APPEAL SUMMARY

Appeal ID: 14936	Project Address: 909 SE 12th Ave
Hearing Date: 4/12/17	Appellant Name: Charles Kidwell
Case No.: B-006	Appellant Phone: 503-228-2840
Appeal Type: Building	Plans Examiner/Inspector: Brian McCall
Project Type: commercial	Stories: 7 Occupancy: M, R-2, S-2 Construction Type: I-A, III-A
Building/Business Name:	Fire Sprinklers: Yes - throughout
Appeal Involves: Erection of a new structure	LUR or Permit Application No.: 16-228563-LU
Plan Submitted Option: mail [File 1]	Proposed use: multi-family residence

Project Title:
MODERA BUCKMAN
APARTMENTS

White Paper - Fire Analysis of Fire Retardant Treated Wood Alternate

Appendix A Figure 2: W-22 Exterior Wall Type

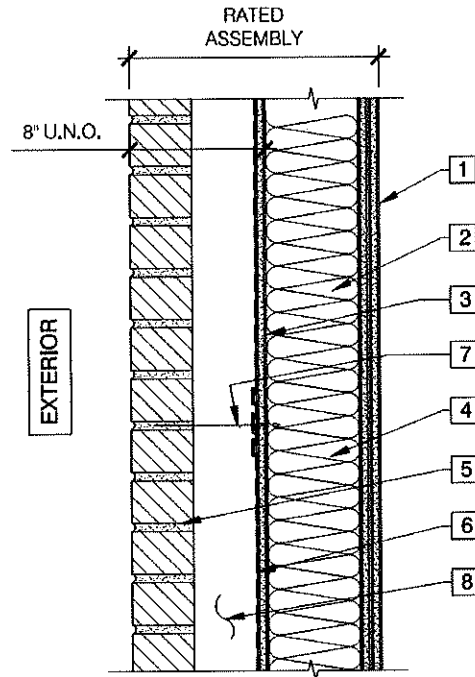
Proposed Design	<p>A. We request the use of regular wood stud framing with the stud cavity filled with mineral wool batt insulation instead of the Fire Retardant Treatment (FRT). The proposed four (4) wall assemblies addressed by this appeal are included in the appendix section of the attached white paper prepared by an Oregon Fire Protection Engineer.</p> <p>B. In addition to the above proposal the project will also satisfy the following conditions:</p> <p>Exterior bearing walls shall be protected based on their fire separation distance as defined in the OSSC as follows:</p>

Use of non-fire resistant treated wood studs in Type IIIA construction: Denied. Insufficient test data to demonstrate equivalent protection. Appellant may contact Terry Whitehill (503-823-7639) with questions.
